Technical Service Information

CHRYSLER A604 DELAYED ENGAGEMENT INTO REVERSE

Figure 1

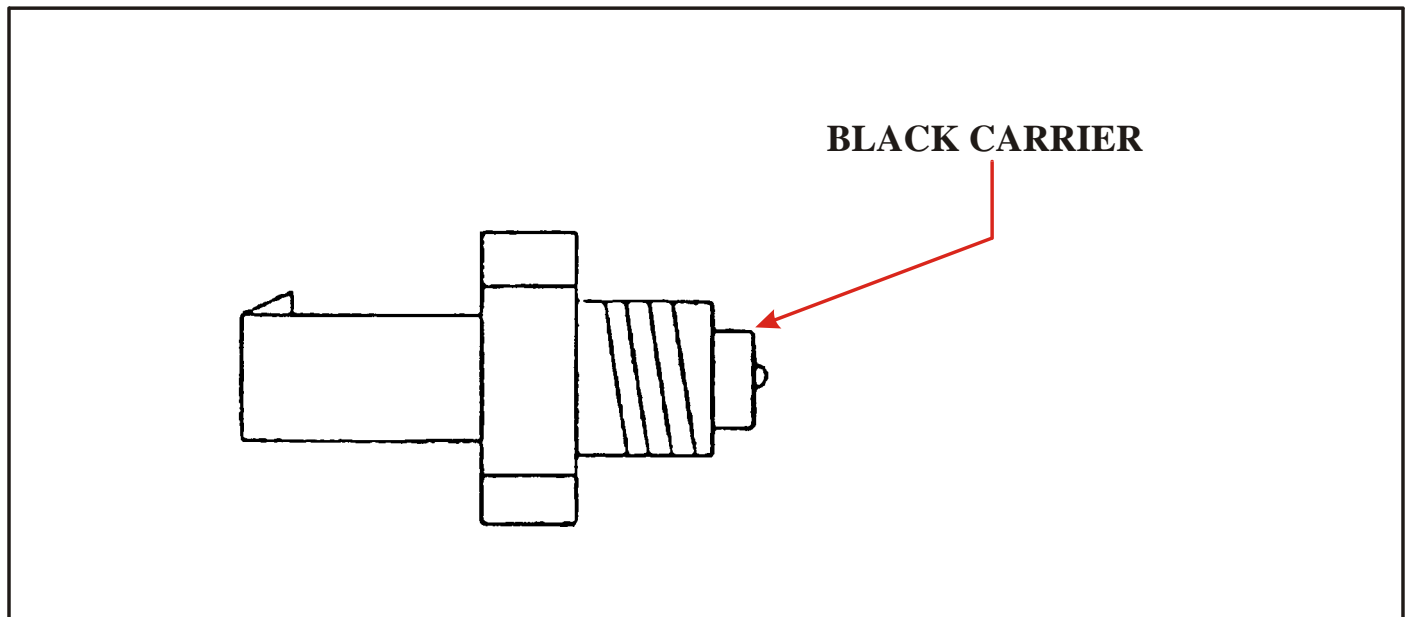
COMPLAINT: Some 1990 vehicles with the A604 Transaxle that were built before January 1, 1990, transaxle date code K xxx 03 84 xxxx may have complaints of intermittent delayed or harsh engagements and occasional default into limp mode or second gear operation only. This can be accompanied by fault codes 22, 37, and 39.

CAUSE: The PRNDL switch may fail to send a consistent signal to the controller. The vehicle may pass the shift lever status test when using a scanner because of the intermittent nature of the failure.

CORRECTION: If the transaxle build date is before date code K xxx 03 84 xxxx, replace the PRNDL switch and washer with part numbers 5234393 and 2408143. Also replace the neutral switch and washer with part numbers 5234319 and 5234023. These parts have been updated and can be identified by the black plastic carrier that extends into the transmission (SEE FIGURE 1).
